Observation Report

Date:	December 16, 2016	Observation Date:	December 9, 2016
Architect:	Cannon Design	Location:	Webster ISB - General
Attn:	Kelvin Patel	Observer:	Patrick Garner
Gen. Contr.:	Paric	M/E/P/F Contr.:	Varies
File:	Webster University Interdisciplinary Science Bldg. WT 14127.01 (7)	c:

Mechanical

Electrical

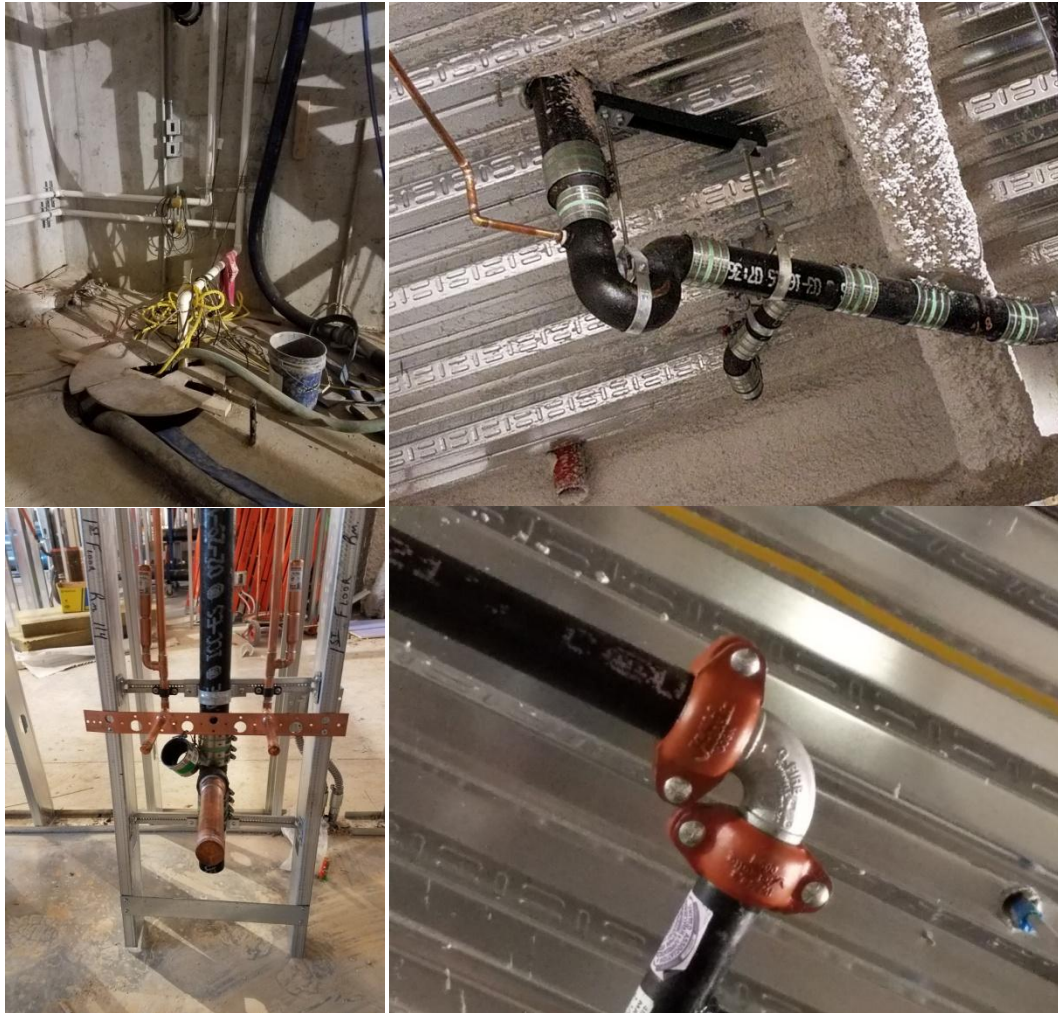
- Electrical systems installation is in progress. The Basement and 1st Floor is farthest along.
- Observed below slab, conduit ends are covered with duct tape. Conduit should be kept free of debris.
- Contractor should confirm that working clearances are maintained as installation progresses.

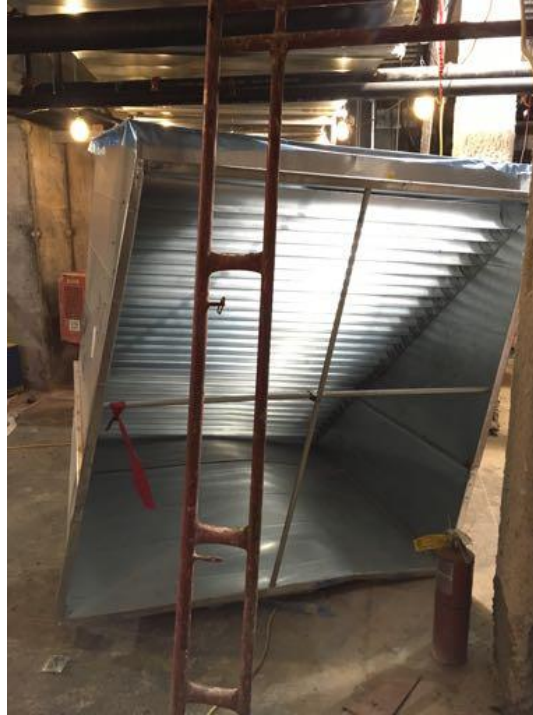
5. Mechanical work is ongoing.
6. Ductwork elbow on floor in basement mechanical room was observed to be dented, bent, and dirty with openings unprotected. Clean and refurbish as required.

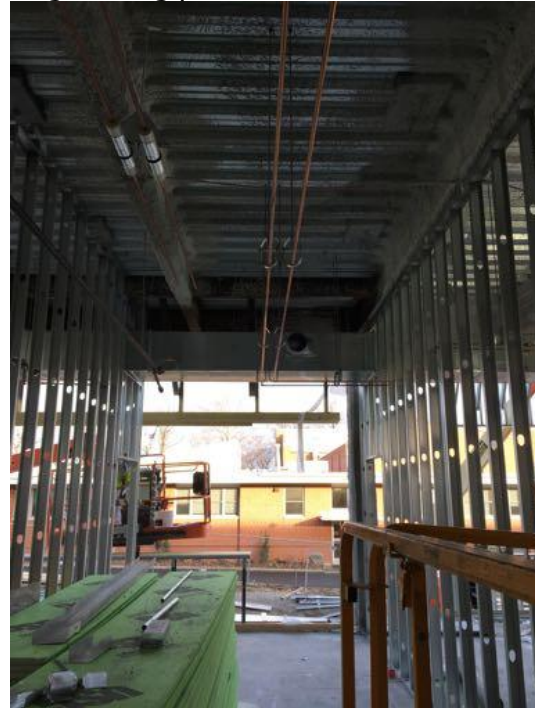
8. VAV-119 has elbow installed very close to box outlet. Confirm this meets the Manufacturer recommended distance from coil / box outlet.
9. VAV115 Takeoff Installed Different than shown on M0101.B (attached to side of duct vs. end of duct). Confirm supply discharge airflow requirements will be met.

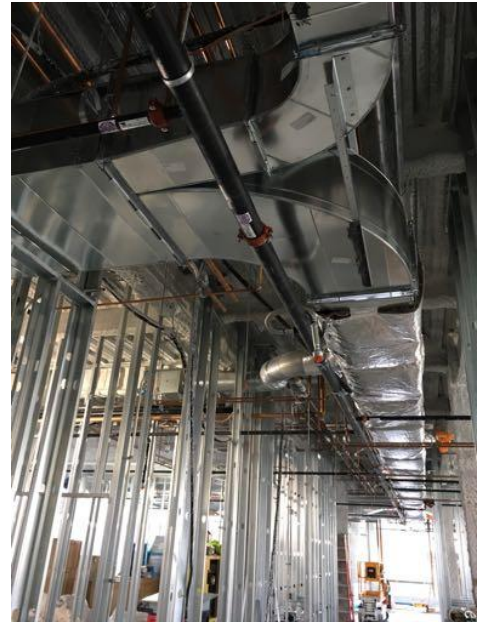
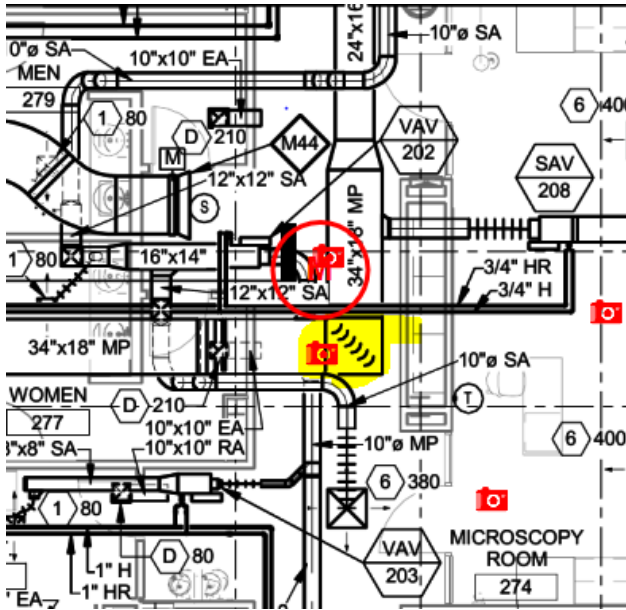
16. Duct elbow highlighted in yellow was not installed per drawings. Instead, a wye fitting has been installed as pictured. Contractor to confirm pressure drops of installed fittings and duct sizes for comparison.

Sheet
M0101.A.02

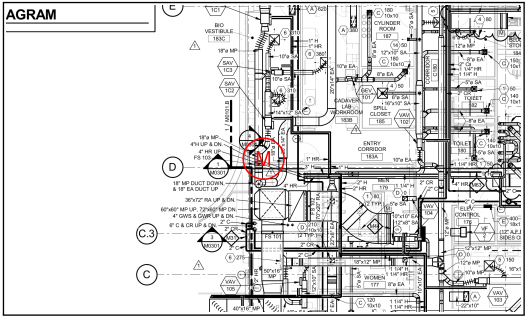
Description
Duct cover is missing.

Sheet
M0101.A.02

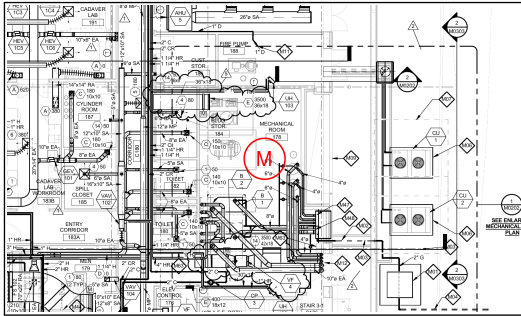
Keep equipment properly protected until start-up.

Sheet
M0101.B.02

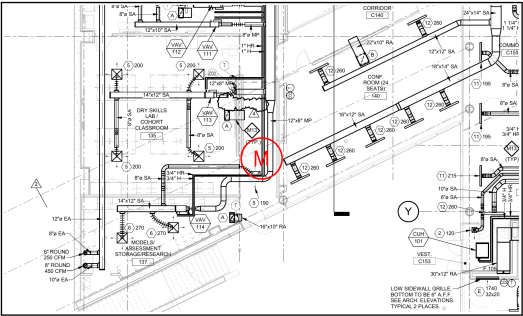
Description
Missing duct cover

Sheet
M0103.A.03

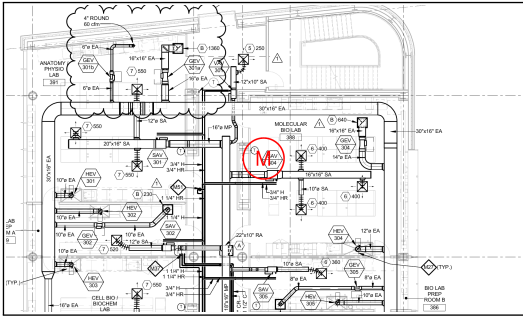
Description
Duct cover missing / blown off

Sheet
M0103.B.03

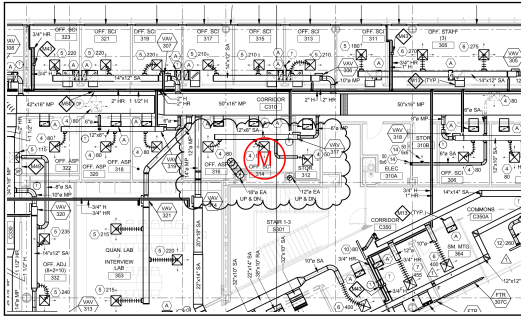
Duct cover blown off

Sheet
M0103.B.03

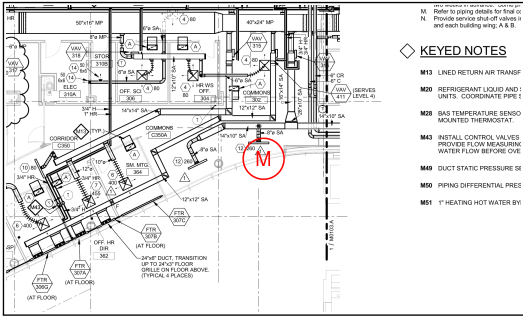
Description
Duct cover missing / blown off

Sheet
M0104.A.03

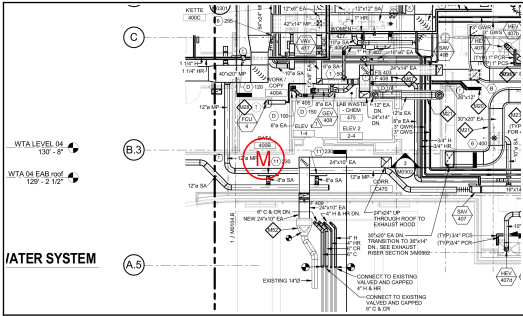
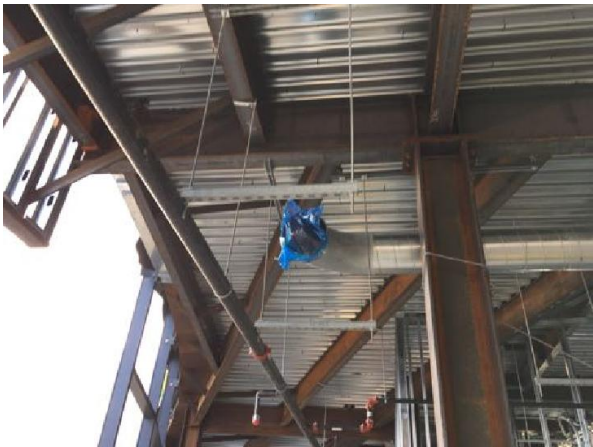
Description
Duct cover blowing off

Sheet
M0104.A.03

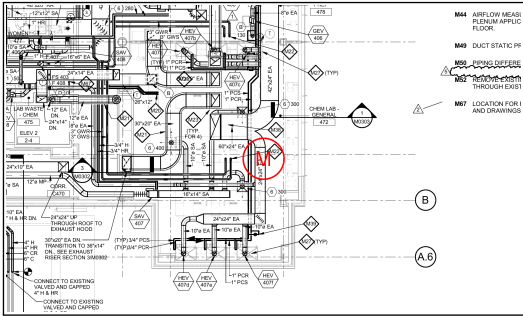
Description
Duct cover missing / blown off

Sheet
M0104.B.02

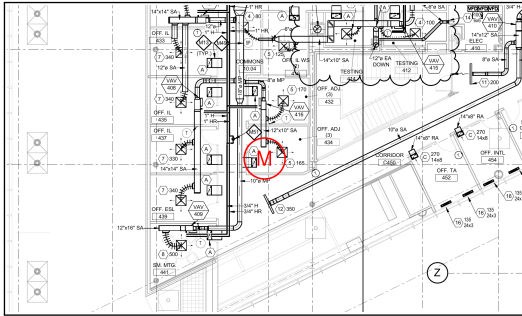
Where installing bottom taps, ensure that offsets are installed between tap and diffuser.

Sheet
M0104.B.02

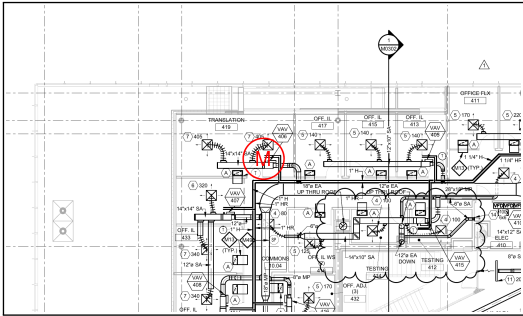
Description
Where installing bottom taps, ensure that offsets are used between tap and diffuser.

Sheet
M0104.B.02

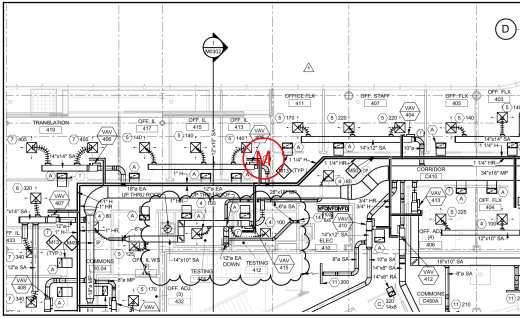
Where installing bottom taps, ensure that offsets are used between tap and diffuser.

Sheet
M0104.B.02

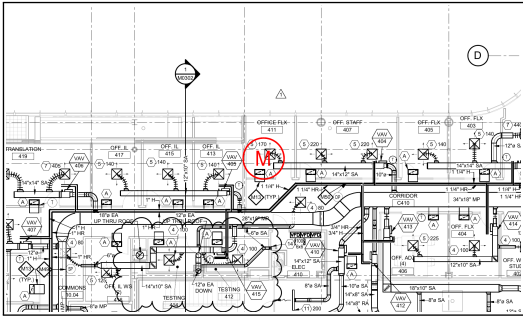
Description
Duct opening not protected

Sheet
M0101.B.01

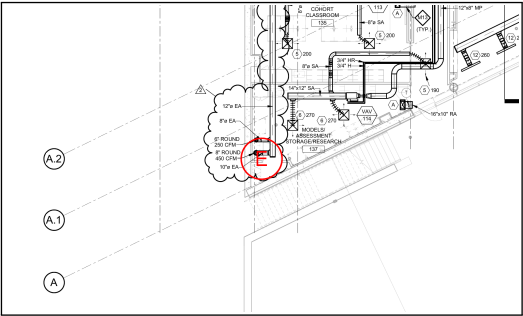
Description
Conduit end not protected.

Sheet
M0103.B.03

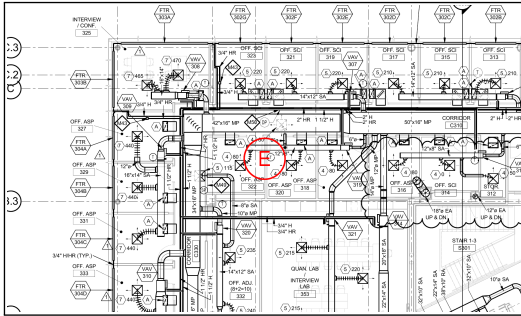
Conduit in conflict with FP piping.

Sheet
M0101.B.01

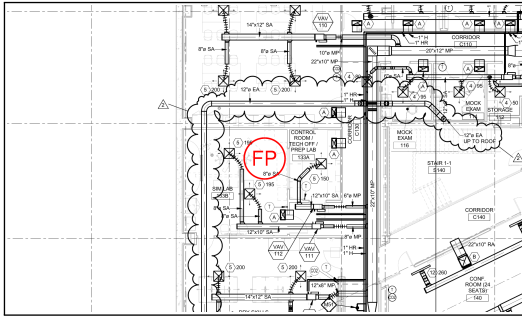
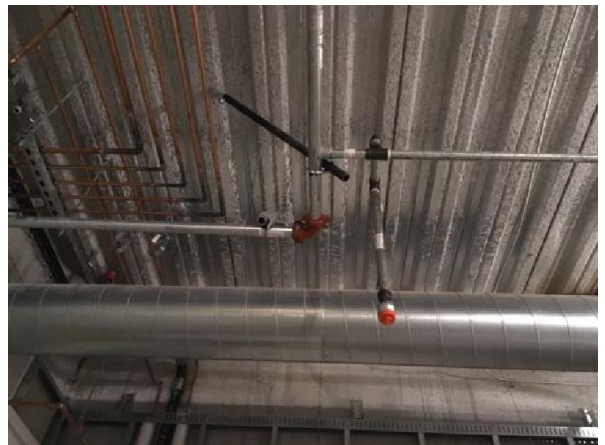
Description
Non galvanized fittings used for pre-action system.

Sheet
M0101.B.01

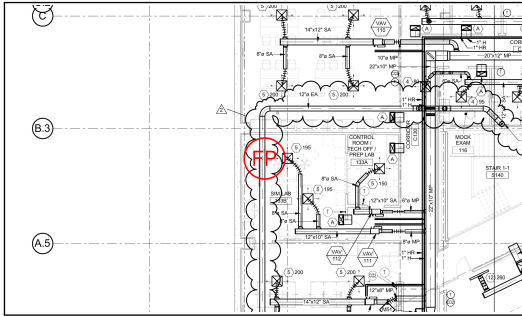
Description
End of line surge restraint missing.

Sheet
M0101.B.01

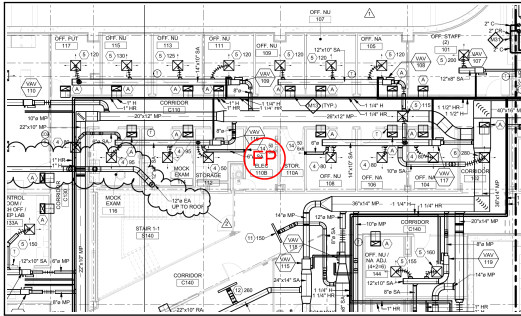
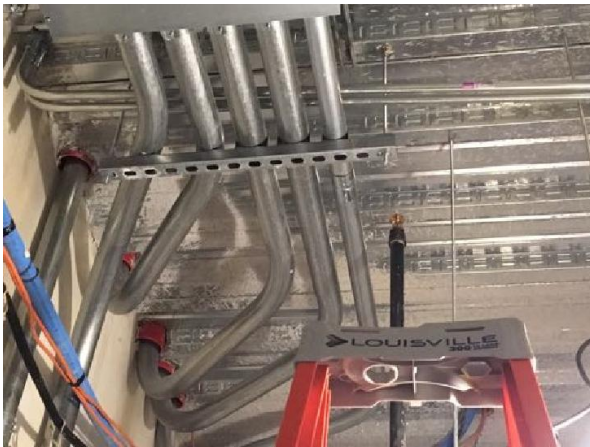
Description
Sprinkler appears to be obstructed.

Sheet
M0101.B.01

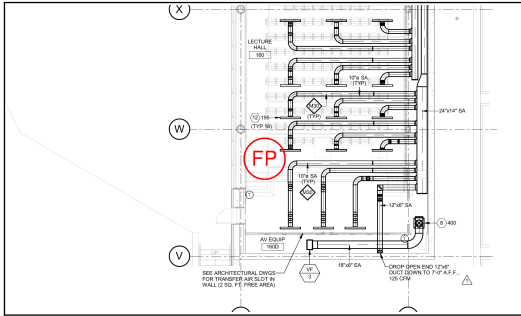
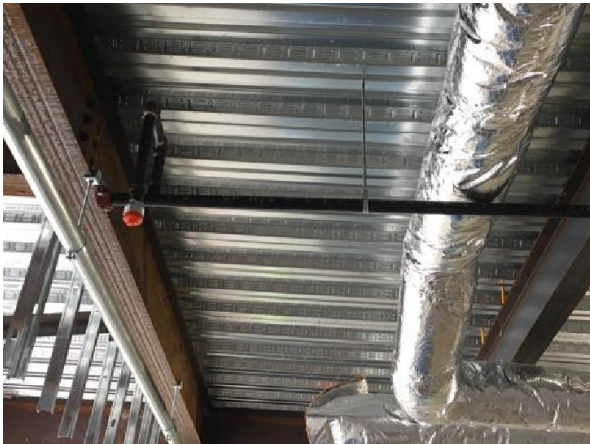
End of branch line appears to need support. This is a typical issue throughout the project. Pressure exceeds 100 psi and support should meet NFPA 13 requirements.

Sheet
M0101.B.01

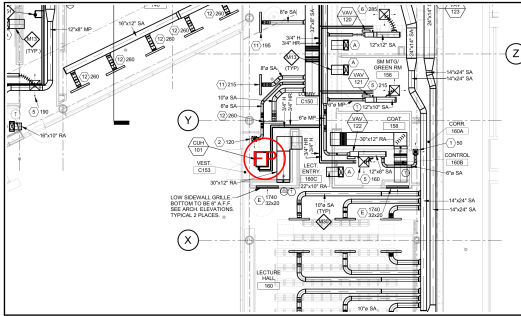
End of line support too far from end of line.

Sheet
M0102.B

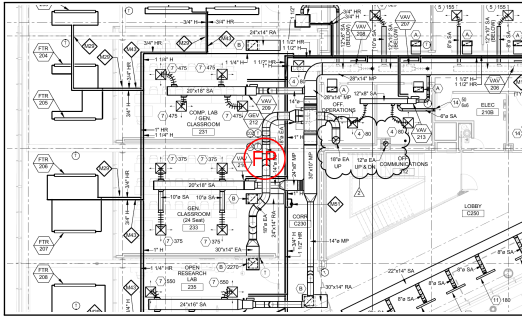
Spkr coupling appears to conflict with duct.

Sheet
M0102.B

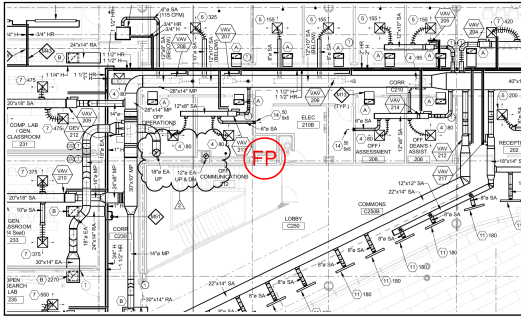
Standpipe connection is open. Should be capped when not being worked on. This is typical throughout the project.

Sheet
M0103.B.03

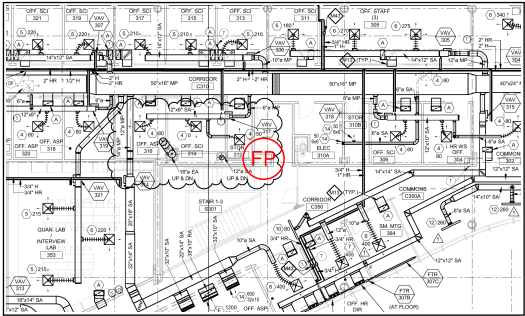
Description
Standpipe hose connection open.

Sheet
M0101.B.01

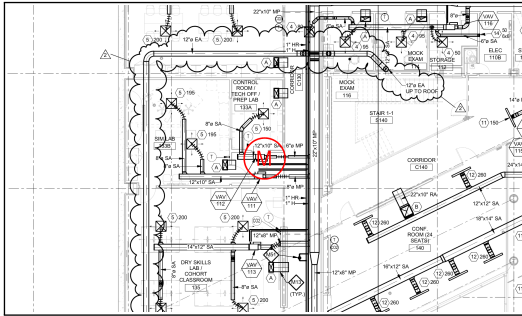
Insulation looks difficult to install on piping at box.

Sheet
M0101.B.01

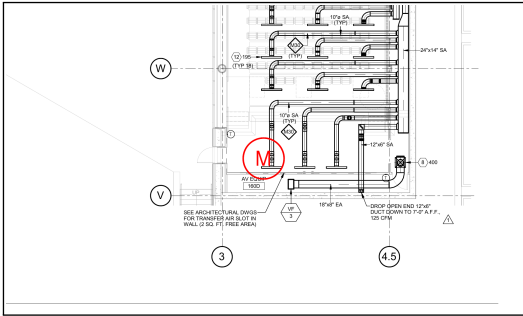
Description
Few open ducts this room.

Sheet
M0102.B

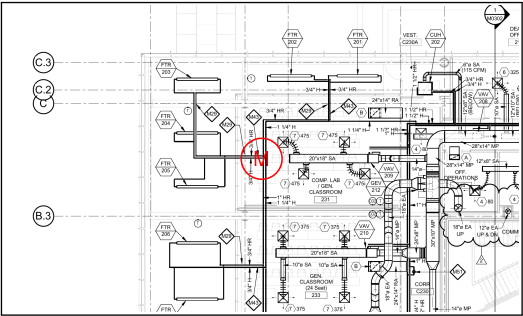
Description
Steel FP piping in conflict with copper hw piping.

Sheet
M0102.B

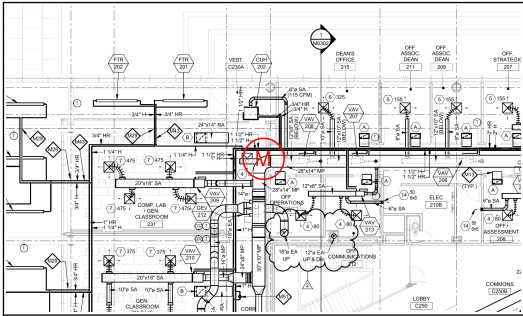
Description
Duct hanger appears to be non traditional.

Sheet
M0103.B.03

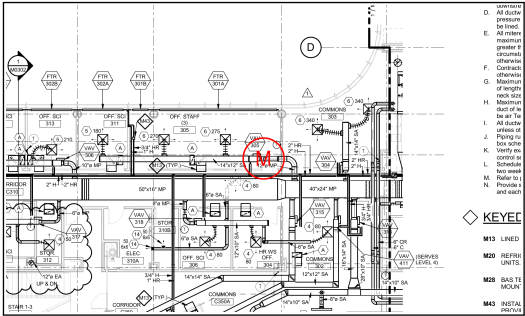
Description
Vav 305 access panel appears to be inaccessible.

Sheet
M0104.B.02

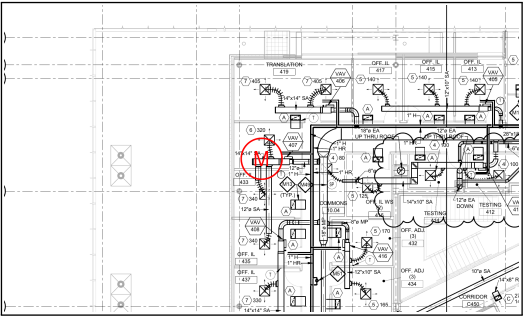
Description
Confusing tap arrangement. Noise is concerning.

Sheet
M0101.B.01

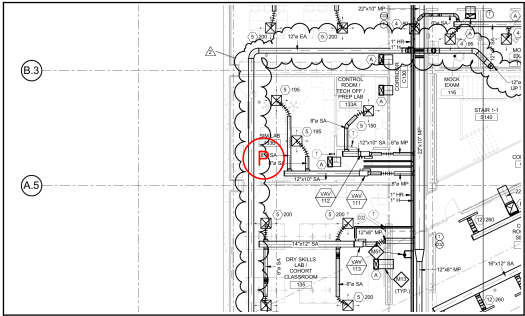
Description
Bent hanger rod.

Sheet
M0101.B.01

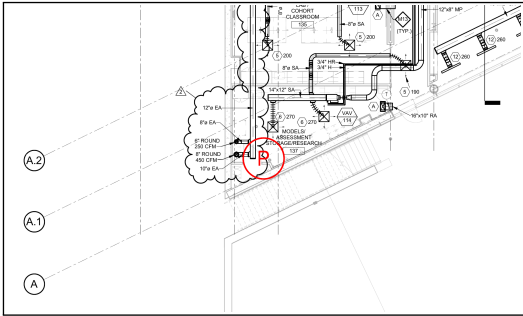
Description
Hanger placed on no hub band.
Should be supported by piping.

Sheet
M0101.B.01

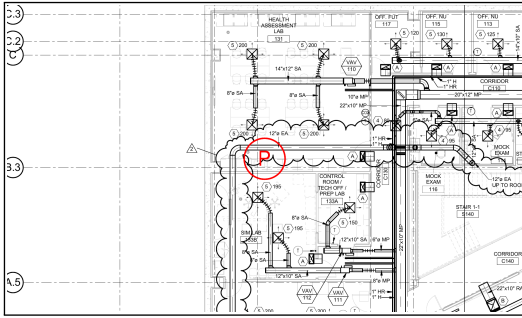
Hanger supporting fitting instead of the piping.

Sheet
M0104.A.03

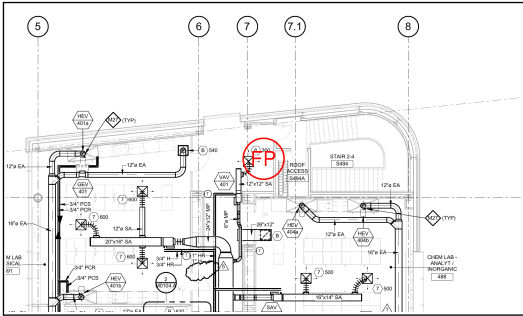
Description
Verify distance before and after flow switch is per manufacturer requirements.

Sheet
M0103.A.03

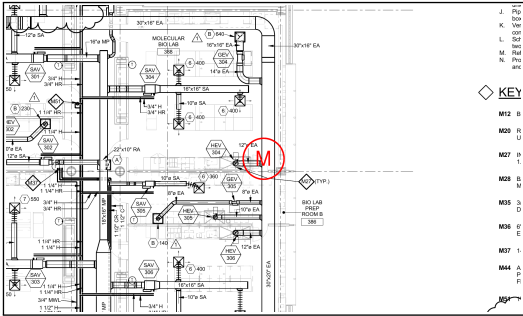
Description
Boot tap not used.

Sheet
M0104.A.03

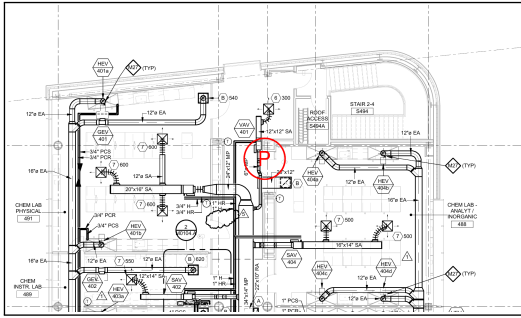
Do not place hangers on no hub bands.

Sheet
M0104.A.03

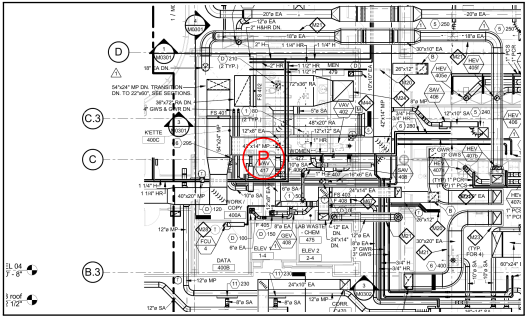
Description
Trash in piping.

Sheet
M0103.A.03

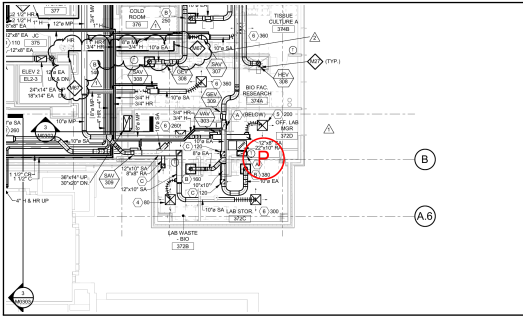
Description
Make sure nail guards are used at necessary locations.

Sheet
M0103.A.03

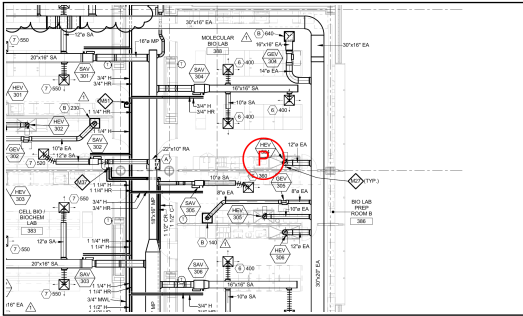
Description
Concerned about copper piping within the stud.

Sheet
M0103.A.03

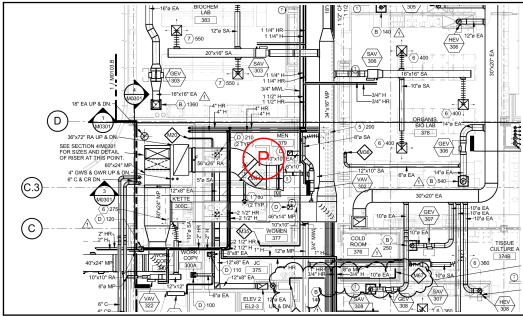
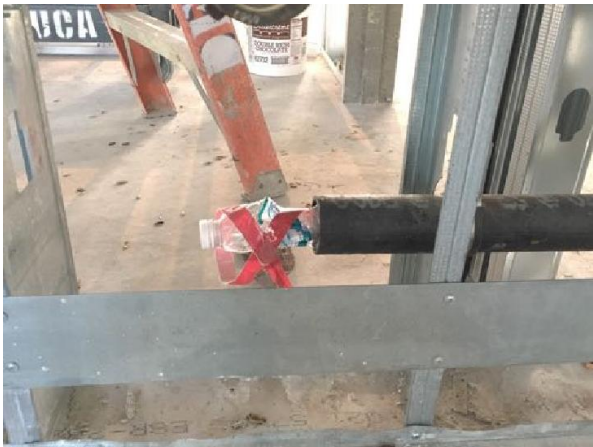
Description
Trash stuffed in pipe.

Sheet
M0102.A.02

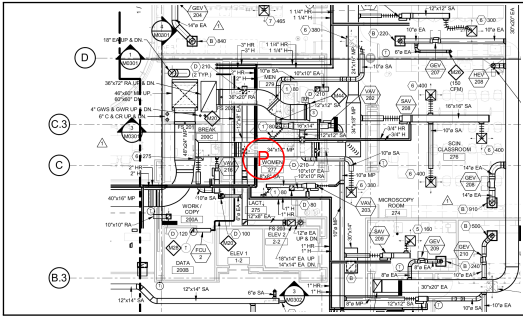
Description
Keep floor drain grates fully protected during construction.
